Access Compliance Report

Public Rights-of-Way

(Curb Ramps)

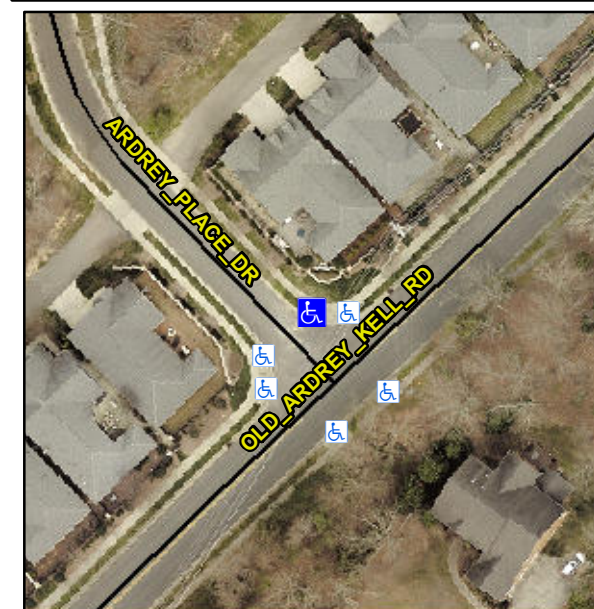
Not Found, R304.5.3

Compliance	Description	Data	Compliance	Description	Data
N/A	Ramp Length (in)	47.5	Yes	Ramp Slope (%)	7.0
Yes	Ramp Width (in)	48.0	No	Ramp XSlope (%)	2.3
N/A	Flare Type LT	N/A	N/A	Flare Type RT	N/A
N/A	Flare Slope LT (%)	N/A	N/A	Flare Slope RT (%)	N/A
N/A	Flare Traversable LT?	N/A	N/A	Flare Traversable RT?	N/A
N/A	Landing Length (in)	N/A	N/A	DWS Provided?	N/A
N/A	Landing Width (in)	N/A	N/A	DWS Contrast?	N/A
N/A	Landing Slope (%)	N/A	N/A	DWS Length (in)	N/A
N/A	Landing X Slope (%)	N/A	N/A	DWS Full Width?	N/A
N/A	Landing Curb? (Y/N)	N/A	N/A	DWS Offset (in)	N/A
N/A	Shared Landing?	N/A			
N/A	Gutter Ponding?	N/A	N/A	Gutter Slope (%)	N/A
N/A	Gutter Lip Ht (in)	N/A	N/A	Gutter X Slope (%)	N/A
N/A	Painted X Walk1?	No	N/A	Painted X Walk2?	N/A
	X Walk 1 Direction	To SW		X Walk 2 Direction	N/A
N/A	X Walk 1 Width (in)	N/A	N/A	X Walk 2 Width (in)	N/A
	X Walk 1 Slope (%)	0.9		X Walk 2 Slope (%)	N/A
	X Walk 1 X Slope (%)	1.1		X Walk 2 X Slope (%)	N/A

Remove & Replace Entire Ramp.
